Product/Process Change Notice (PCN)																	
<input type="checkbox"/> Major Change <input checked="" type="checkbox"/> Minor Change																	
PCN Number: PCN_PeRATR_20251222 Affected Series: WP-RATR Affected Part Number: see table "PART NUMBER, REVISION & DATASHEET" PCN Date: 2025-09-22 (YYYY-MM-DD) Effective Date: 2025-12-22 (YYYY-MM-DD)	Change Category: <input type="checkbox"/> Equipment/Location <input checked="" type="checkbox"/> General Data <input type="checkbox"/> Material <input type="checkbox"/> Process <input type="checkbox"/> Product Design <input checked="" type="checkbox"/> Shipping/Packaging <input type="checkbox"/> Supplier <input type="checkbox"/> Software																
Contact: Product Management Phone: +49 (0) 7942 - 945 5001 Fax: +49 (0) 7942 - 945 5179 E-Mail: pcn.eican@we-online.com	Datasheet Change: <input checked="" type="checkbox"/> Yes <input type="checkbox"/> No Attachment: <input type="checkbox"/> Yes <input checked="" type="checkbox"/> No																
DESCRIPTION OF CHANGE: <p>Due to an improvement of the production capability, Würth Elektronik eiSos will change the packaging from carton case to carton tray. The new carton will change

DETAILS OF CHANGE:												
<ul style="list-style-type: none"> Pictures & dimensions 												
Before Change	After Change											
Carton Case (SPQ)	Carton Tray (SPQ)	Shipping Carton (CPQ)

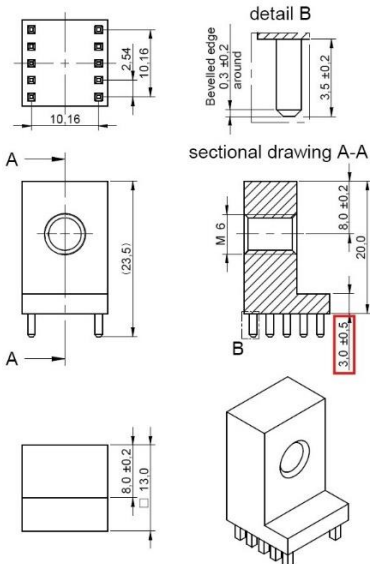
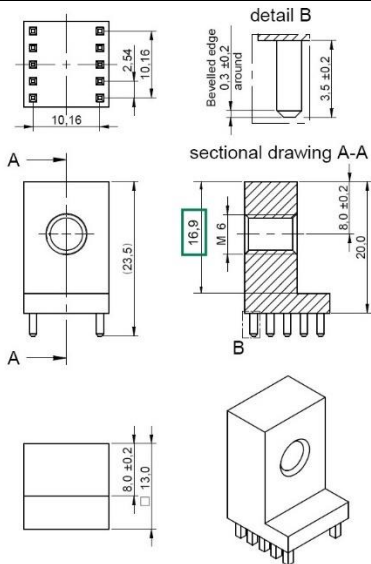
Dimensions (LxWxH):	Dimensions (LxWxH):	Dimensions (LxWxH):										
108.0 x 85.0 x 65.0 mm	274.0 x 171.0 x 15.0 mm	300.0 x 200.0 x min. 115.0 mm Height varies depending on the component due to two-part carton.										
<ul style="list-style-type: none"> Datasheet 												
Before Change	After Change											
General Information:												
<table border="1"> <tr> <td>Material</td> <td>Brass</td> </tr> <tr> <td>Surface</td> <td>Tin</td> </tr> <tr> <td>Execution</td> <td>Press-Fit</td> </tr> <tr> <td>Operating Temperature</td> <td>-55 up to +150 °C</td> </tr> <tr style="border: 2px solid red;"> <td>Packaging</td> <td>Bulk</td> </tr> </table>			Material	Brass	Surface	Tin	Execution	Press-Fit	Operating Temperature	-55 up to +150 °C	Packaging	Bulk
Material	Brass											
Surface	Tin											
Execution	Press-Fit											
Operating Temperature	-55 up to +150 °C											
Packaging	Bulk

Part Number	Before Change	After Change	
	SPQ: Carton Case	SPQ: Carton Tray	CPQ: Shipping Carton
7461064	75	93	279
7461106	75	93	279
7461107	75	93	279
7461108	75	93	279
